## **EcoNetwork – Port Stephens Inc.**

### **Submission**

#### **Tomaree Coastal Walk and proposed visitor facility improvements for Tomaree National Park, Port Stephens.**

Tuesday, 20 October 2020

Figure 1. South slope of Stephens Peak showing instability zone with four active slope failures (A, B, C, D) and several historic slope failures.

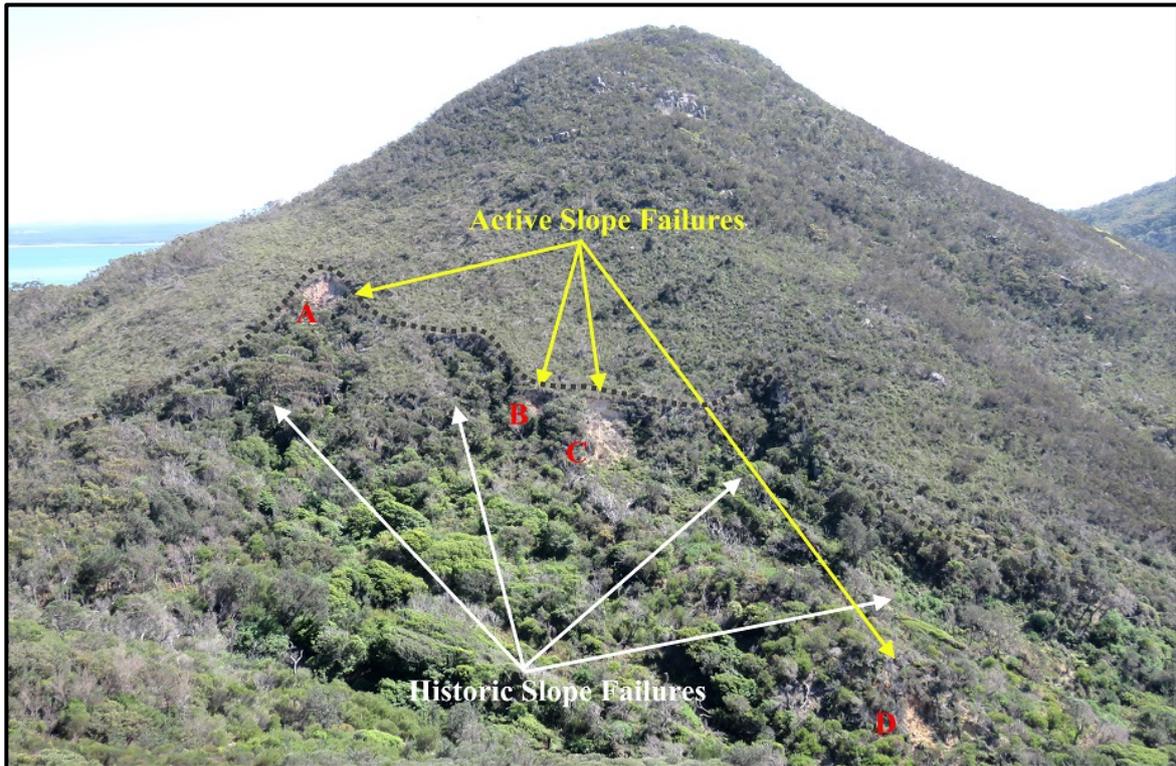
On the south slope of the peak there are four active slope failures within a zone failure over 200m long. These are indicated as A, B, C, D in **Table 1** below. There are also at least four historical slope failures within this zone (see **Figure 1**). On the east slope of the peak there is an active slope failure (E) and two active slope failures on the north slope (F, G). The dimensions of these failures are estimated from satellite imagery and summarised in the table.

Fraser notes that the debris from failures A, B C and D is predominantly soil and from failures E, F and G predominantly rock. The toe of Failure D has reached the gully between Stephens Peak and Quarry Hill where it is being eroded by water flows during periods of high rainfall, which will result in continued future movement of this failure. Debris from failure E has reached the ocean and includes blocks up to 5m in length. Debris from failures F and G has reached Zenith Beach a similar slope failure is present on Tomaree Head at the north end of Zenith Beach. These slope failures are rotational landslides induced by saturation of the slopes during periods of high rainfall.

According to Fraser, construction of tracks across these slopes enhance access for rainwater into the ground and produce additional failures or remobilize existing failures. As well as damaging the environment, failures would constitute significant risk to the safety of track construction workers and users. Additional slope failures would badly disfigure an otherwise scenic landscape.

Fraser recommends as does EcoNetwork that in view of his analysis plans for tracks across the eastern slopes of Stephens Peak and Quarry Hill should be abandoned.
